Evaluation of Bridge Rail Cracking – N. Ohio St. Overpass Salina Kansas

Report to
City of Salina, KS
300 W. Ash
P.O. Box 736
Salina KS 67402

October 2, 2007

CTLGroup Project No. 210706

Fig. 3 – Finite Element Rendering of Pedestrian Fence Interior Unit

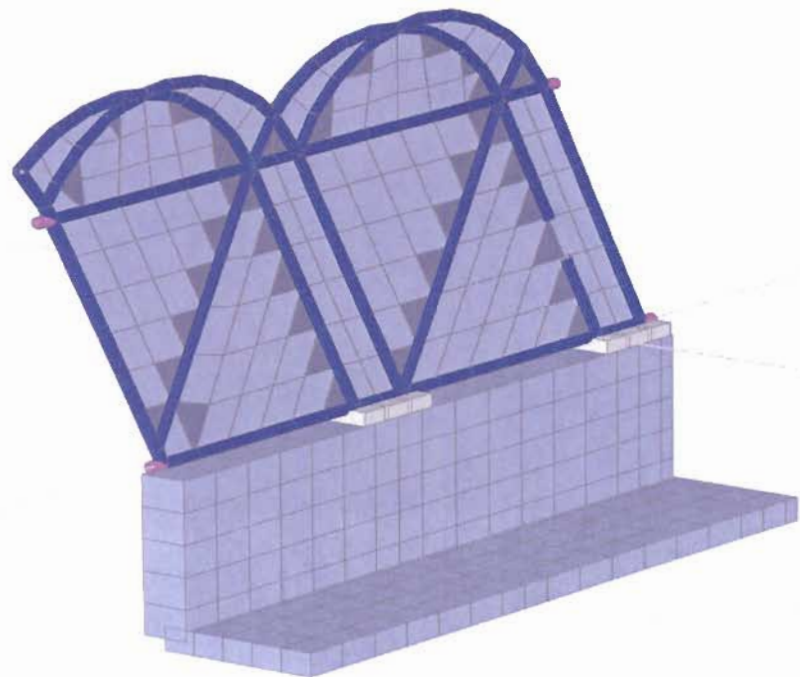
A finite element analysis of the roadway fence was created to analyze the reactions at the fence base; see Figs 3 and 4. The AASHTO Group V load combination was used for determination of the reactions at the fence base. Based on the fence installation occurring in February, a temperature gradient of 40°F was applied to the model to obtain thermal forces.

Although the anchor plates were detailed with slotted holes the connection was conservatively assumed fixed. This assumption was based on two primary factors. First, the original design model for the fence system assumed complete fixity of the fence anchorages and the intent of CTL's analysis was to approximate the original design. Secondly, considering the design life of the structure, length of the fence, unique geometry of the individual units, steel plates bolted to concrete, total number of anchorages, configuration of slip joints, and environmental exposure, it is our opinion that the anchorage should be analyzed for a fixed condition. This is part due to corrosion restricting or preventing longitudinal movement. It should be noted that rust was already visible, as shown in Fig. 1, on at least one slip joint during CTL's site visit. Table 1 lists a comparison of the CTL analysis and original design calculations for the fence reactions transferred to the anchorage. Additionally, anchorage capacity was calculated in accordance with ACI Appendix D for comparison against the design calculations. The accepted procedure
